# 1420 RIDGECREST DR. – Replacement Front Door, After-the-Fact Rear Double Doors (H24-049-COA)

CITY OF HENDERSONVILLE - COMMUNITY DEVELOPMENT - HISTORIC PRESERVATION  
COA STAFF REPORT

REQUEST I: REPLACEMENT FRONT DOOR - SITE IMAGES

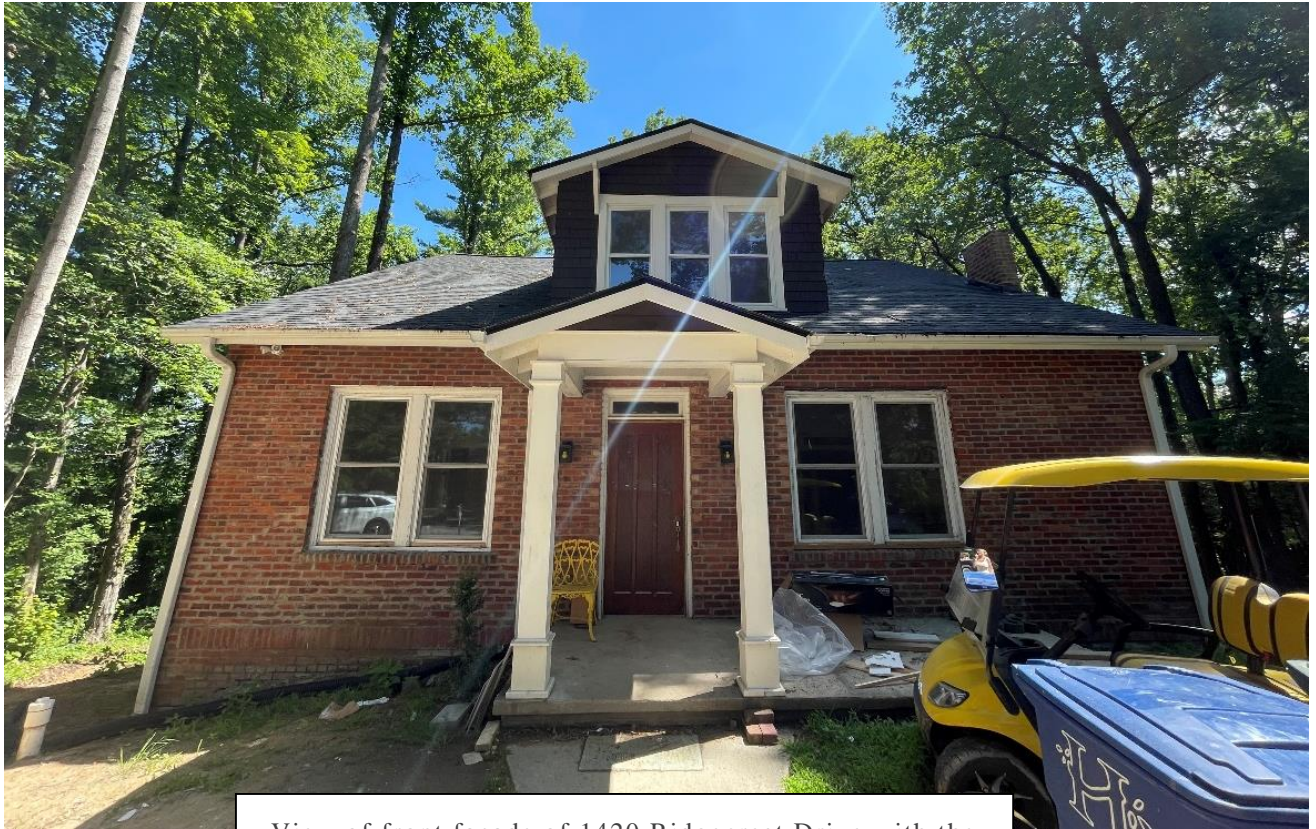
**REQUEST I: Replacement Front Door.** The applicant is seeking approval for a new front door, to be based on the current front door's design.

View of front façade of 1420 Ridgecrest Drive with the existing front door.

Close up of front door.

Damage to interior of front door.

REQUEST II: AFTER-THE-FACT REAR DOUBLE DOORS

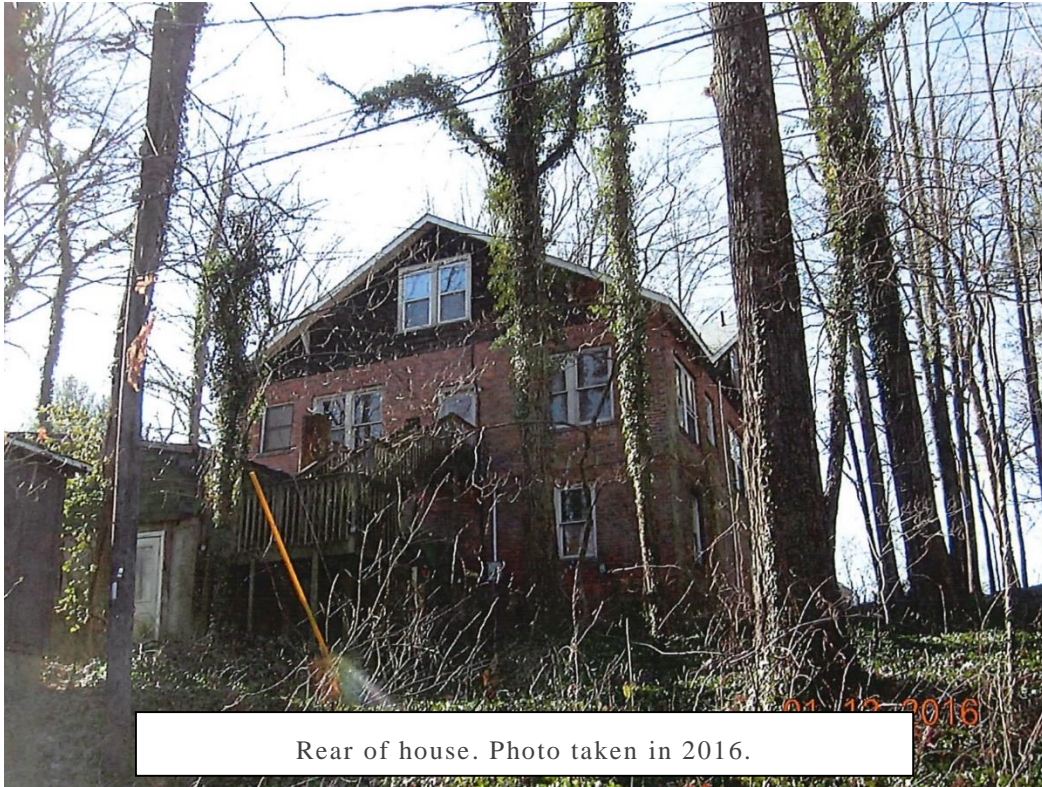
**REQUEST II: After-the-Fact Rear Double Doors.** The applicant is seeking after-the-fact approval for double doors that were installed on the rear of the house. The double doors are located where two windows were previously located.

Rear of house before double windows were replaced with double doors.

Double doors replaced the spot previously occupied by two windows on the rear of the house.
